Access Audit Site Report

Fort Richardson State Park and Historic Site

Accessibility Evaluation

Inspection Date: 05/16/2022

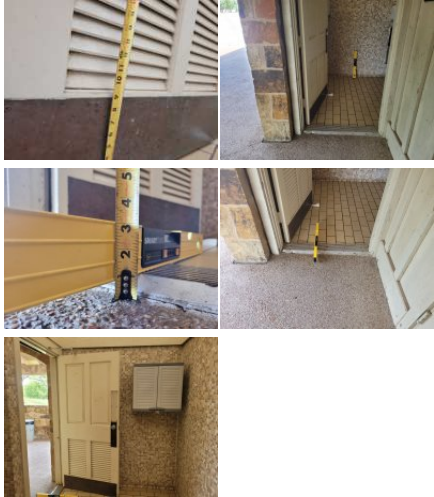
32	Headquarters Area: HQ - Men's Restroom	[33.2061613, -98.1569856]	The mirror is mounted too high. Mirrors must have the bottom edge of the reflecting surface a maximum of 40 inches above the floor if above a sink or counter. Mirrors not located above lavatories or countertops shall be installed with the bottom edge of the reflecting surface 35 inches maximum above the finish floor or ground.	Top of reflective surface at 61" AFF	Raise mirror so top reflective surface is 74" AFF.	2015 ABAAS Section: 603.3 2012 TAS Section: 603.3 2010 ADAS Section: 603.3

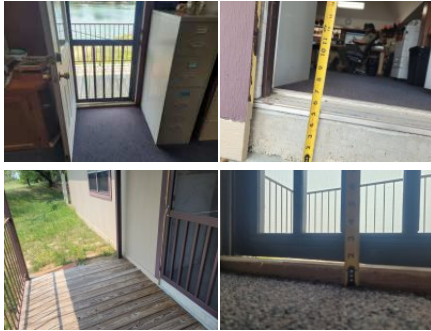
43	Headquarters Area: HQ - Women's Restroom	[33.2061512 , -98.156999]	The toilet is not located within the range allowed from the side wall or partition. The centerline of the toilet must be 16 to 18 inches from the side wall.	centerline 18.5" to wall	Remount toilets to 16" to 18" from the side wall to centerline.	2015 ABAAS Section: 604.2 2012 TAS Section: 604.2 2010 ADAS Section: 604.2

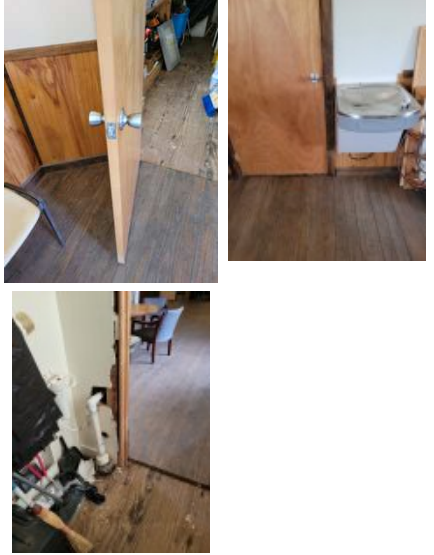
67	Parade Ground: Parade Ground - Parking	[33.2059066 , -98.1632097]	The accessible parking stall signage is incorrect and/or missing from each accessible parking space. Parking space identification signs shall include the International Symbol of Accessibility. Signs identifying van parking spaces shall contain the designation "van accessible." Signs shall be 60 inches minimum above the finish floor or ground surface measured to the bottom of the sign.	parade ground- lacks accessible parking sign	Acquire and mount at appropriate heights and locations accessible parking signs where missing.	2015 ABAAS Section: 502.6 2012 TAS Section: 502.6

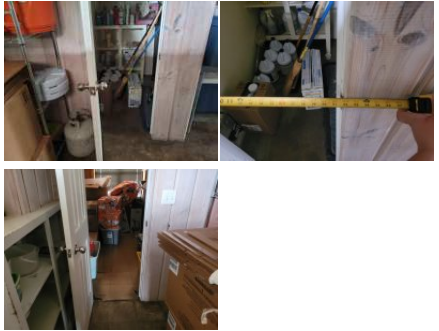
96	Parade Ground: Parade Ground - Dining Hall	[33.2096903 , -98.1617492]	There are no accessible bathing or shower facilities. Where facilities for bathing are provided for the public, clients or employees, including showers or bathtubs, at least one shower or bathtub and support facilities such as lockers, and not less than 1 percent of all facilities, shall be accessible.	2nd floor shower-lacks accessible shower - 2 of 2 have significant CIL at entry	Create an accessible shower in locker/bathing room.	2015 ABAAS Section: F213.3.6 2012 TAS Section: 213.3.6 2010 ADAS Section: 213.3.6

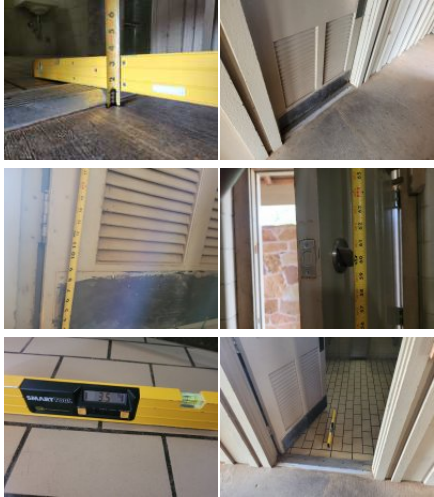
295	Campsites & Cabins: Men's Restroom	[33.2008547, -98.163347 8]	The shower seat does not have a compliant space between it and the wall. The folding seat must be mounted 17-19 inches above the floor, and have a maximum space of 1-1/2 inches between the edge of the seat and the side wall and 2-1/2 inches maximum to the seat wall.	Seat is 3.5" from wall	Remount shower seat to the correct location and height in the shower.	2015 ABAAS Section: 610.3.2 2012 TAS Section: 610.3.2 2010 ADAS Section: 610.3.2

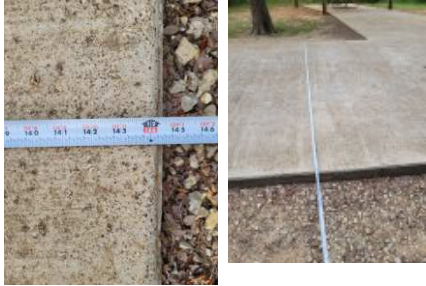
335	Lost Creek Reservoir: Campsites	[33.24282, -98.13955]	Water spouts at water hydrants and water utility hook-ups shall be 28 inches (710 mm) minimum and 36 inches (915 mm) maximum above the ground.	Site 1 - water spout at 14" AGL	Remount water spouts to 28" min or 36" max above the ground as a smart practice.	2015 ABAAS Section: 1011.6		
336	Lost Creek Reservoir: Campsites	[33.2428096, -98.1395218]	30 inches (760 mm) by 60 inches (1525 mm) with the long side of the space adjoining or overlapping an accessible parking space or pull-up space for recreational vehicles. Locate the space so that the hook-ups are at the rear center of the space. Bollards or other barriers shall not obstruct the clear ground space in front of the hook-ups	Site 1 - lacks clear space at electric hook up and water, too far off parking pad	Provide required 30" by 60" clear ground space with hook ups at the rear of the space as a smart practice.	2015 ABAAS Section: 1011.2

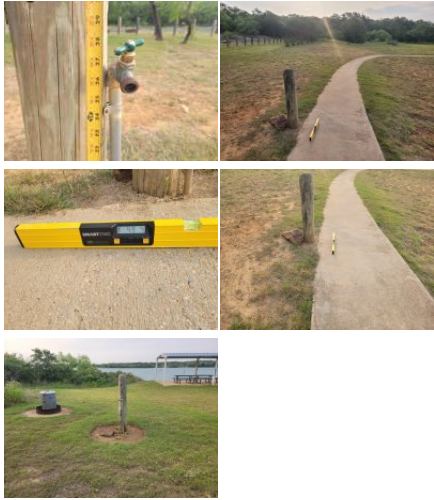
339	Lost Creek Reservoir: Campsites	[33.2426099 , -98.139846 3]	An accessible access route is not provided between elements, spaces and the facilities provided within the accessible camping unit. At least one outdoor recreation access route shall connect accessible elements, spaces and facilities provided within camping units with mobility features.	Site 3 - lacks route to fire pit/grill and utility access	Create AR with crushed and compacted stone or similar outdoor material to camp sites and one of each type of amenity.	2015 ABAAS Section: F244.5.1
